HISTORIC PRESERVATION BOARD

AGENDA

**PUBLIC HEARING
50 EXCHANGE STREET**

Application for: **Certificate of Appropriateness for Rooftop Addition,
Architectural Lighting & Masonry Repairs**

4TH FLOOR & ROOF PLANS

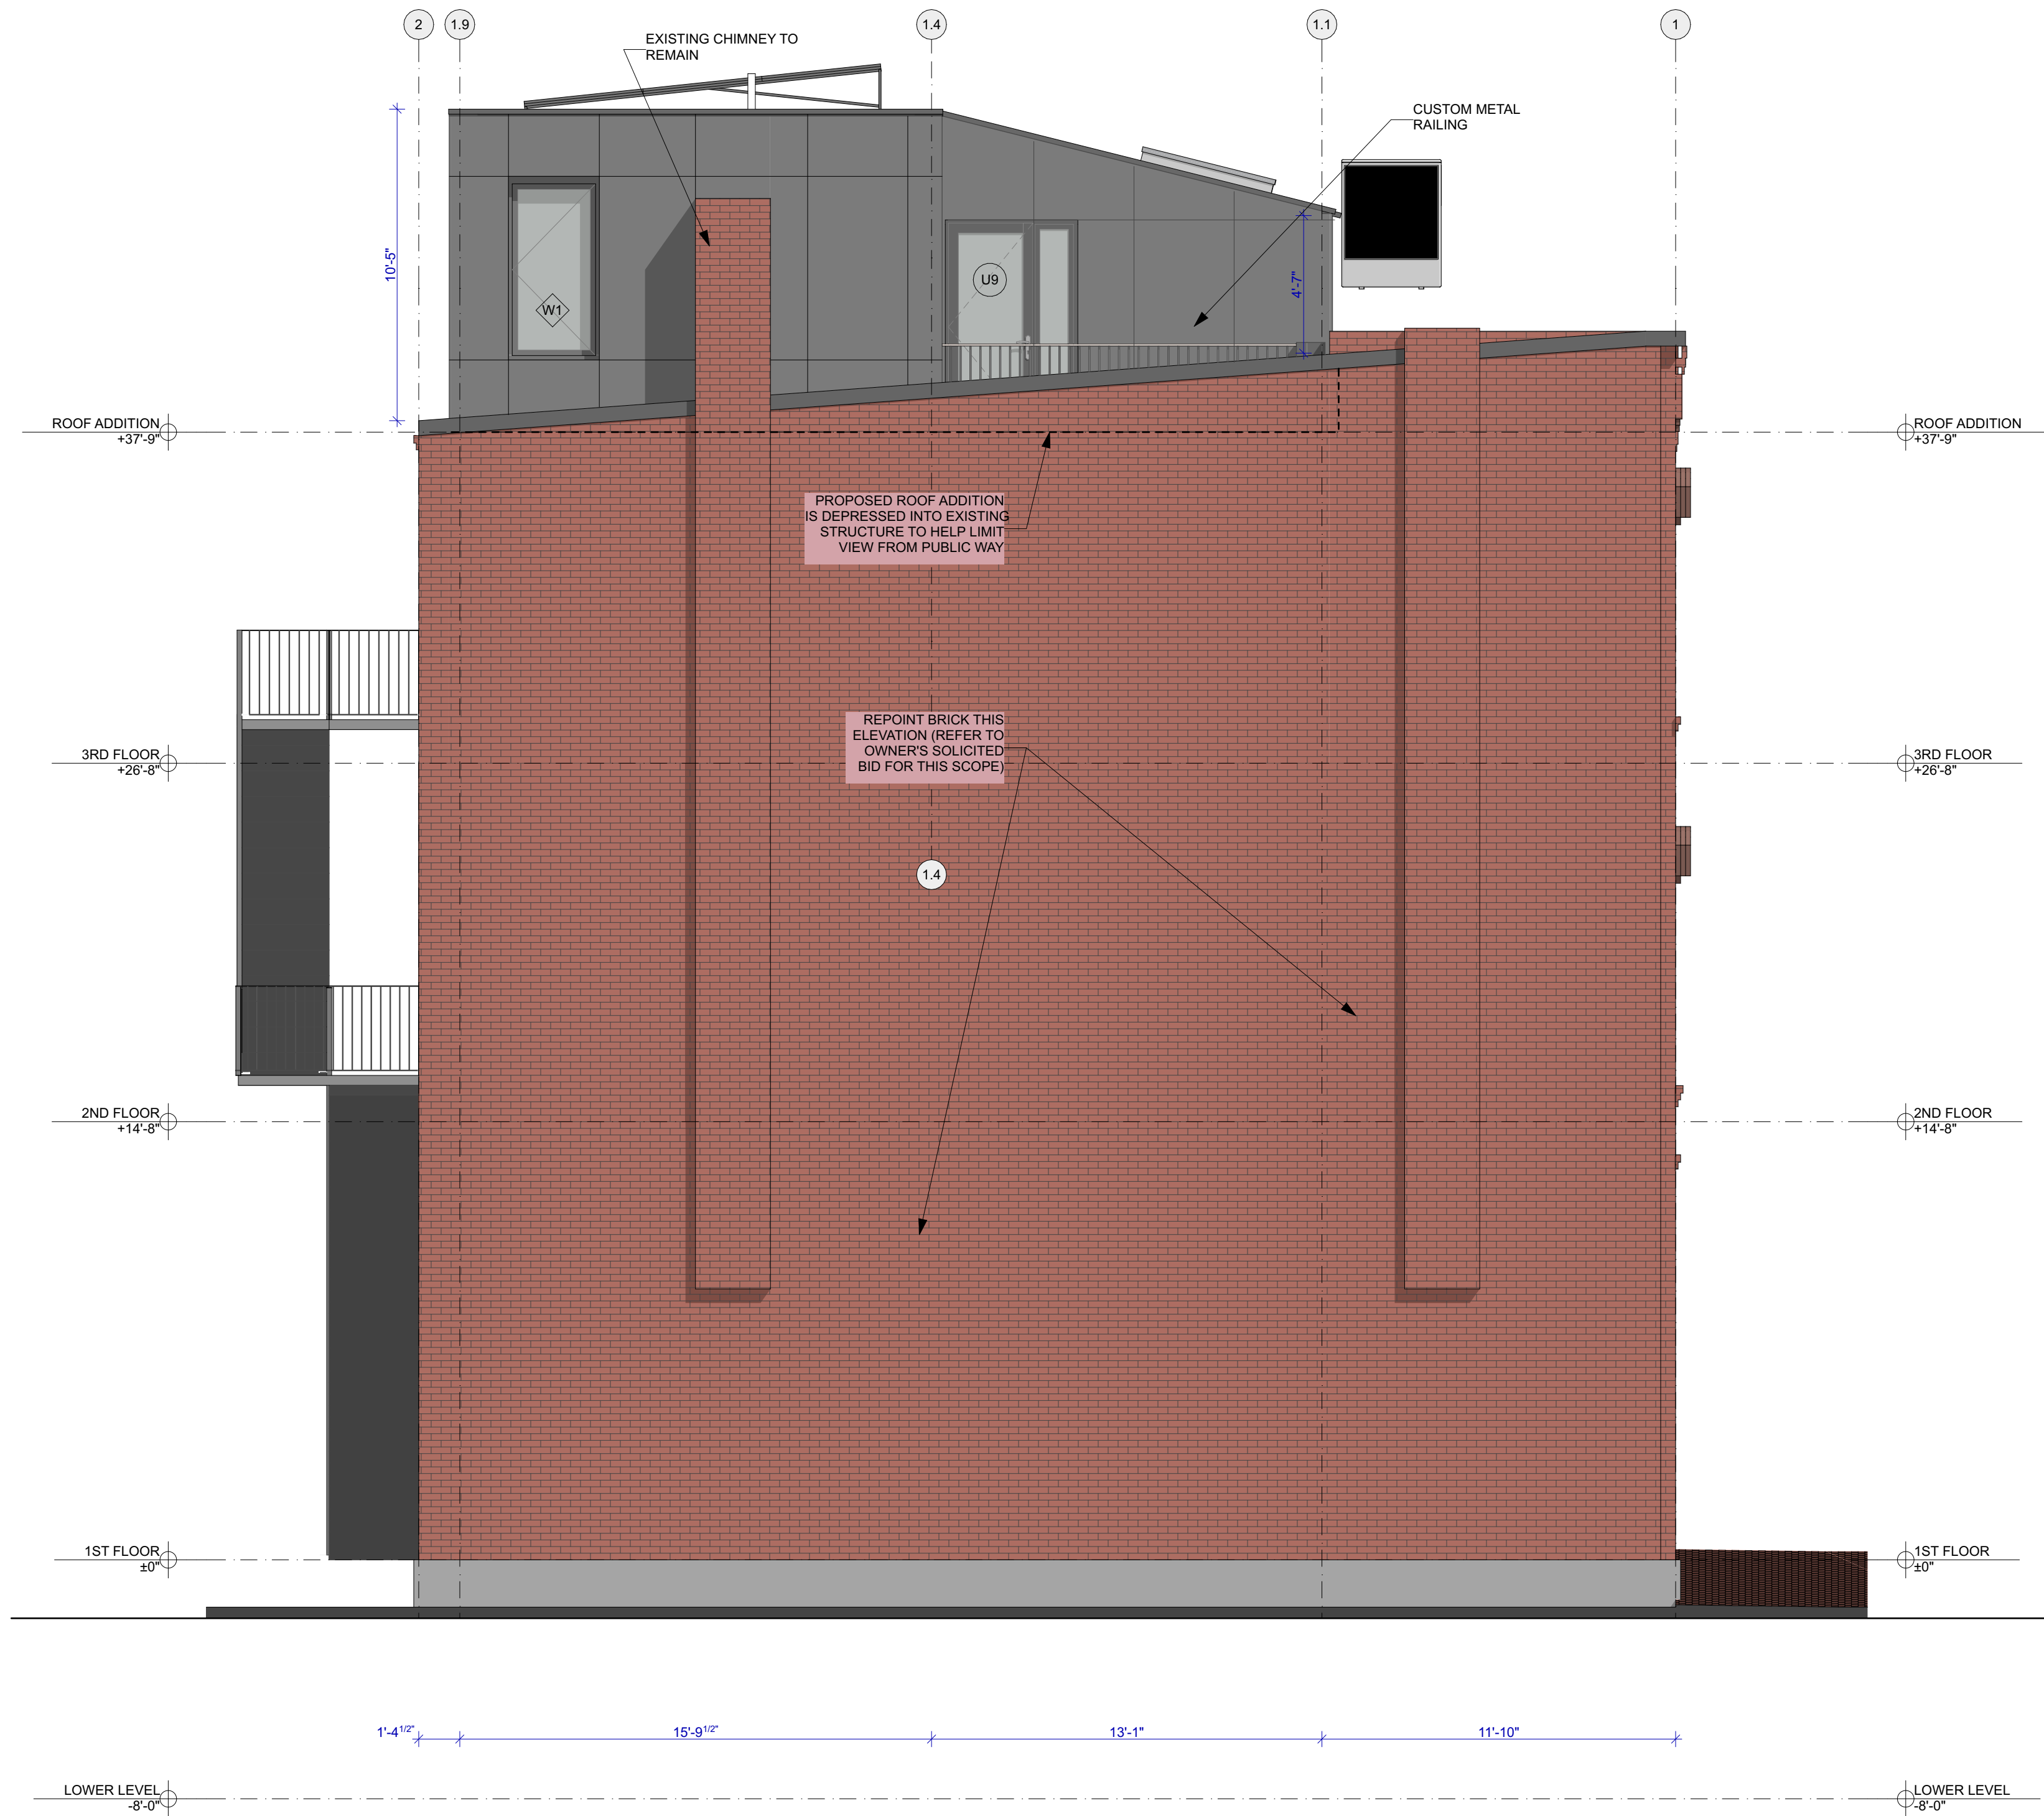
As Mr. Boothe states in his cover letter, the addition has been designed to have limited visibility from the public way. To achieve this, the proposed addition has been set down into the existing structure (as shown on Sheet A-201 south elevation). It is also irregular in form, with the portion closest to the street only 38 feet wide and set back 11' 10" from the Exchange Street façade and 11 feet from the building's side walls. The roof of this front section slopes toward Exchange Street (3/12 pitch) and includes two skylights. The addition widens toward the back of the building, occupying almost the full width of the roof. The addition is set back 1' 8 ½" from the rear and side elevations. The roof over this rear section is flat.

Plans call for solar panels to be mounted on the flat portion of the addition's roof. The panels are mounted at a slight pitch. Also shown are two heat pumps mounted to the front elevation of the addition. The heat pumps are centered on the wall and mounted perpendicular to it. This position, presumably, has been chosen to limit their visibility from the street.
